Project	<b>IEEE 802.16 Broadband Wireless Access Working Group</b> < <a href="http://ieee802.org/16">http://ieee802.org/16</a> >	
Title	<b>Prescribing the timing for MAC PDU transmission</b>	
Date Submitted	<b>2007-07-05</b>	
Source(s)	Rakesh Taori, Ki-Sun Oh, Mi-Sun Do Samsung Advanced Institute of Technology	Voice: +82 31 280 9635 E-mail: rakesh.taori@samsung.com
	Hyunjeong Kang and Jungje Son Samsung Electronics	*< <a href="http://standards.ieee.org/faqs/affiliationFAQ.html">http://standards.ieee.org/faqs/affiliationFAQ.html</a> >
Re:	In response to the call for comments and contributions on the IEEE 802.16j baseline draft (802.16j-06/26r4).	
Abstract	[Description of document contents.]	
Purpose	Discussion and Adoption in the IEEE 802.16j baseline draft	
Notice	<i>This document does not represent the agreed views of the IEEE 802.16 Working Group or any of its subgroups. It represents only the views of the participants listed in the "Source(s)" field above. It is offered as a basis for discussion. It is not binding on the contributor(s), who reserve(s) the right to add, amend or withdraw material contained herein.</i>

## **Prescribing the timing for MAC PDU transmission**

Figure 22a: Header format of relay MAC PDU with payload

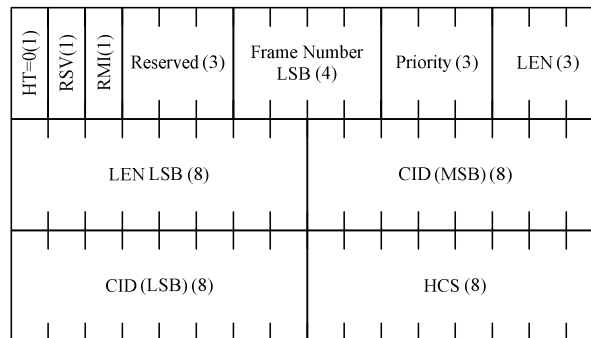
The foregoing problems can be overcome by letting the BS specifically prescribe the time when the RS should transmit the MAC PDUs. In 802.16 j, the simplest way to include timing information is by means of Frame Number, i.e. when sending a relay MAC PDU to the RS, the BS can instruct the RS in which frame the MPDU should be transmitted.

Efficiency can be obtained by prescribing only the last 4 LSBs of the frame number.

Modify Figure 22a as shown below:

In case of centralized scheduling, the MR-BS uses the frame number to instruct the RS exactly when it should relay the payload contained in the MAC PDU with the relay MAC header. The MR-BS uses 4 LSBs of the frame number to specify the frame in which the payload must be forwarded.
